# REPORT ON CONSULTATION

## Draft Amendment 57 Blocks 12 & 13 Section 9 Barton

July 2009

**Figure 8 - The Central National Area (Barton)**

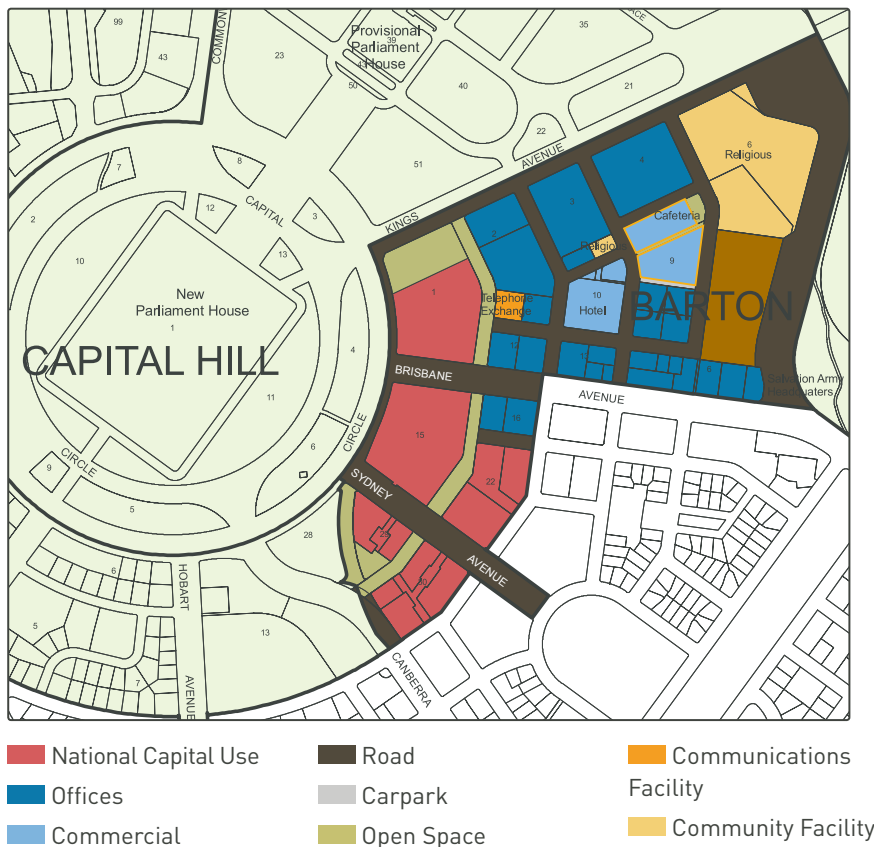
- a) Delete the existing Figure 8 The Central National Area (Barton) and substitute the following Figure 8 The Central National Area (Barton).
